Job 72423785REP1	Truss A03	Truss Type Truss	Qty 16	Ply 1	Service - 1400 RANCH PLAN RF Job Reference (optional)
---------------------	--------------	---------------------	-----------	----------	--

Repair for a break in the web where indicated.

Job 72423785REP1	Truss A03	Truss Type Truss	Qty 16	Ply 1	Service - 1400 RANCH PLAN RF Job Reference (optional)
---------------------	--------------	---------------------	-----------	----------	--

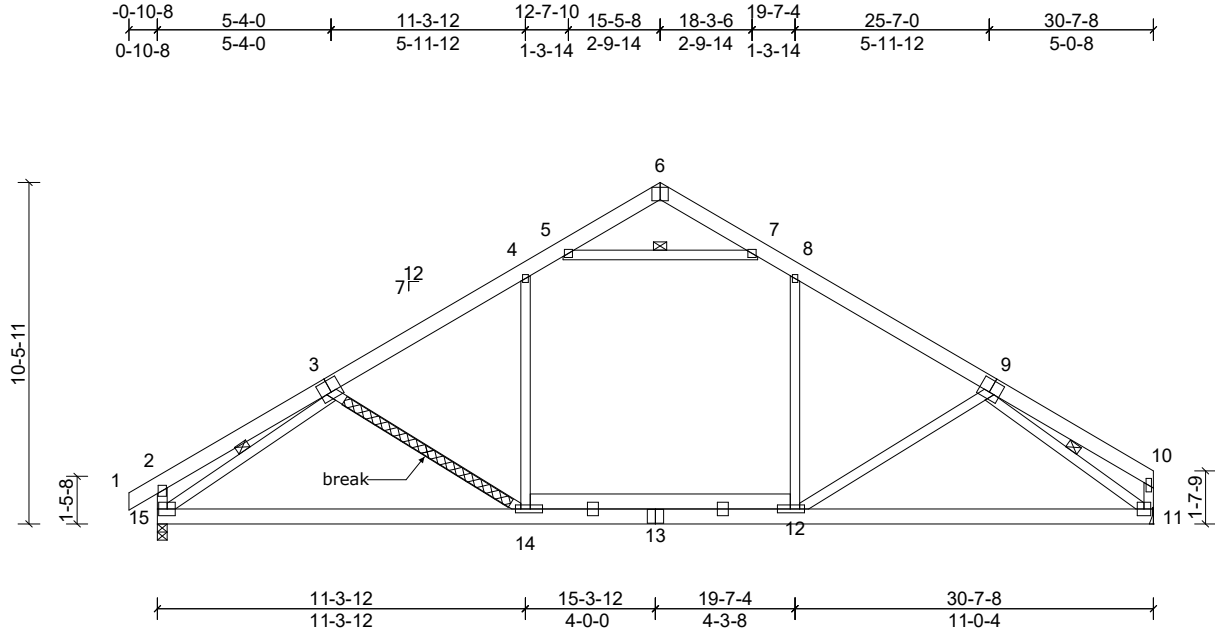
Repair for a break in the web where indicated.

Attach 2x4 x 6' SP or SPF No.2 scab to each face of truss centered at the break with 2 rows of 10d (.131" x 3") nails spaced 4" oc
